MEMORANDUM

RE: Laurel Island PUD (REVISIONS)

Laurel Island Planned Unit Development Charleston, South Carolina

d. Height District LI 12.

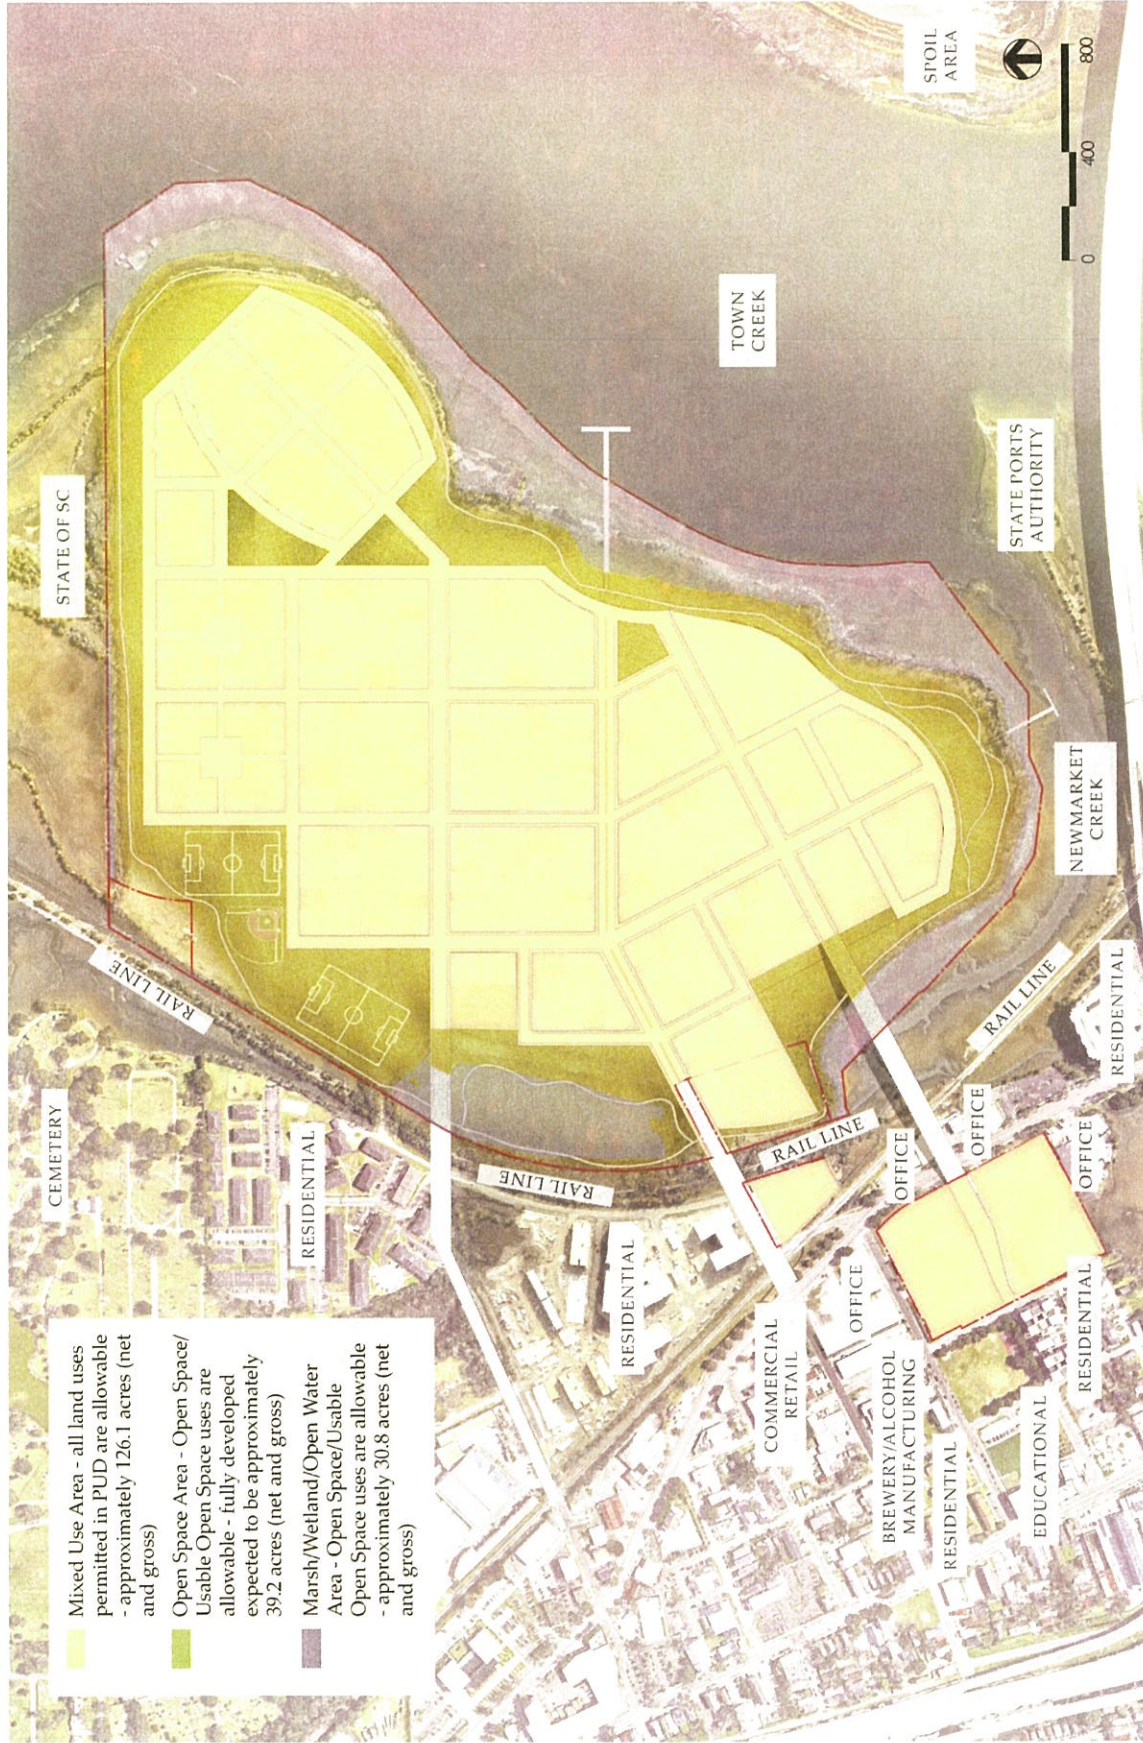
7. **Section 4.1 (Building Heights)**: Section 4.1 has been revised to incorporate a new exhibit addressing building heights, attached as Exhibit 2. The revisions and exhibit do not substantively change what was requested in the previous version of the Laurel Island PUD. The height district plan, showing the location of each height district, is attached as Exhibit 5. The previous version of the PUD permitted adjustment to the height district boundaries reflected on Exhibit 5. The revisions ensure that the boundaries may be changed only based upon the final location of the constructed rights-of-way, with any major expansion of a height district boundary requiring approval of City Council through an amendment to the PUD.

Maximum building height shall not exceed twelve stories.

Any nonresidential ground floor shall not be less than 12 feet in height and no more than 16 feet in height, unless a waiver is granted for additional height of the floor by the Laurel Island Board of Architectural Review.
